SUNDRY NOTICES AND REPORTS ON WELLS

Ripple 32 Fed Com 713H (FKA 727H) API #: 30-025-53415

EOG respectfully requests an amendment to our approved APD for this well to reflect the following changes:

Revised Permit Information 05/10/2023:

WELL LOCATION AND ACREAGE DEDICATION PLAT

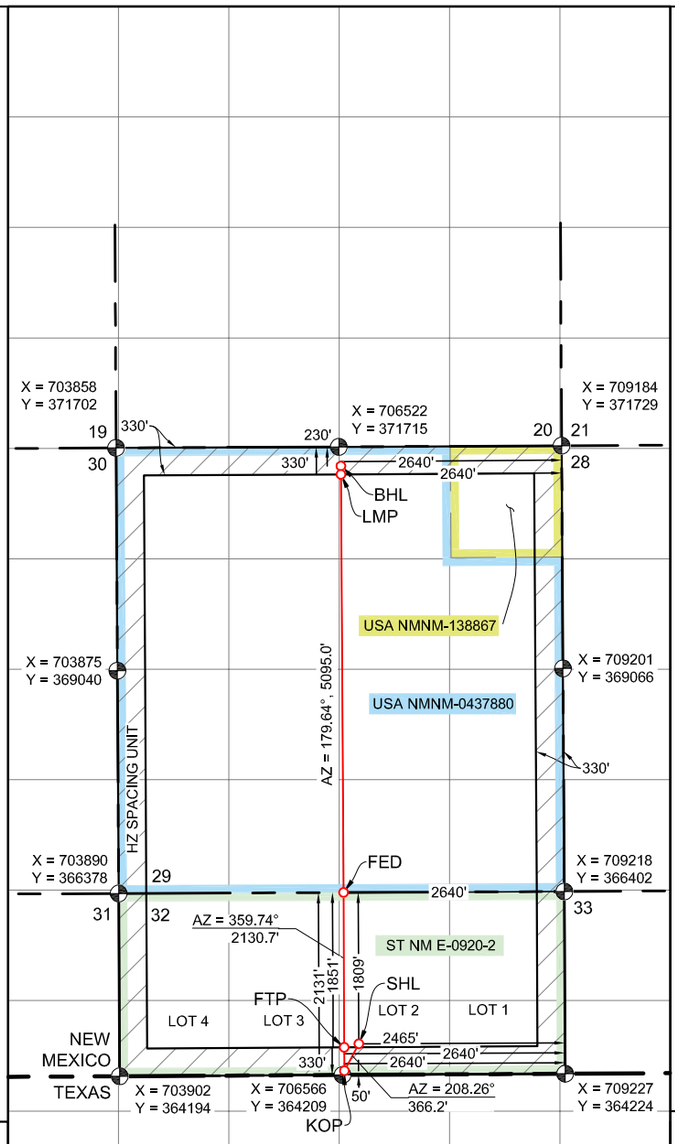
Change name from Ripple 32 Fed Com 727H to Ripple 32 Fed Com 713H.
Change BHL from T-26-S, R-31-E, Sec 29, 1561' FNL, 2310' FEL, Eddy Co., NM,
to T-26-S, R-31-E, Sec 29, 230' FNL, 2640' FEL, Eddy Co., N.M.

UL or lot no.	Section	Township	Range	Lot Idn	Feet from the	North/South line	Feet from the	East/West line	County
B	29	26 S	31 E		230	NORTH	2640	EAST	EDDY

BOTTOM HOLE LOCATION
NEW MEXICO EAST
NAD 1983
X=706546' Y=371485'
LAT=N32.020172°
LONG=W103.800270°
NAD 1927
X=665359' Y=371428'
LAT=N32.020047°
LONG=W103.799795°
230' FNL 2640' FEL

Revised Wellbore

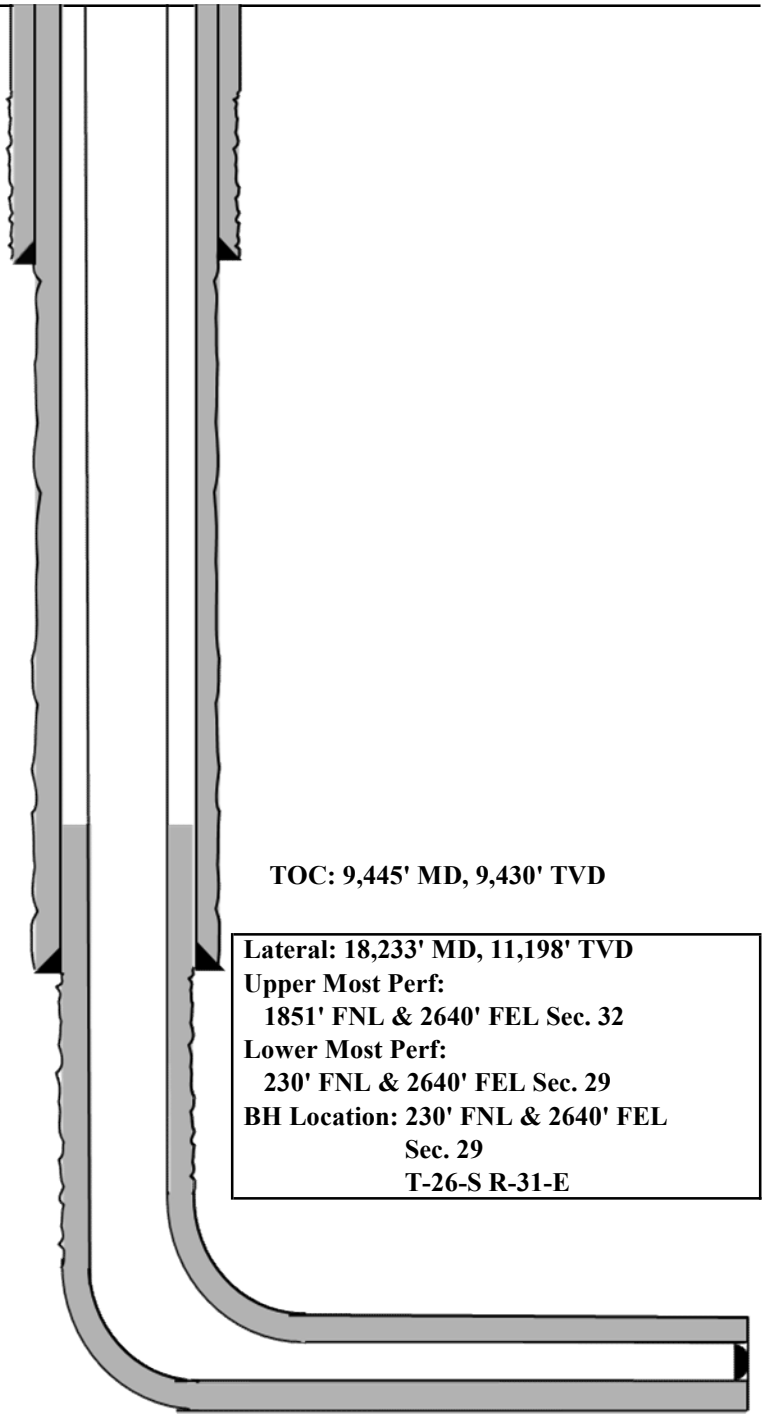
Update casing and cement program to current design.

Bit Size: 12-1/4"
9-5/8", 36#, J-55, LTC,
@ 0' - 1,030'

Bit Size: 8-3/4"
7-5/8", 29.7#, HCP-110, FXL,
@ 0' - 9,945'

Bit Size: 6-3/4"
5-1/2", 20#, P110-EC, DWC/C IS MS,
@ 0' - 9,445'
5-1/2", 20#, P110-EC, Vam Sprint SF,
@ 9,445' - 9,945'
5-1/2", 20#, P110-EC, DWC/C IS MS,
@ 9,945' - 18,233'

KOP: 10,735' MD, 10,720' TVD
EOC: 11,485' MD, 11,198' TVD

TOC: 9,445' MD, 9,430' TVD

Lateral: 18,233' MD, 11,198' TVD
Upper Most Perf:
1851' FNL & 2640' FEL Sec. 32
Lower Most Perf:
230' FNL & 2640' FEL Sec. 29
BH Location: 230' FNL & 2640' FEL
Sec. 29
T-26-S R-31-E
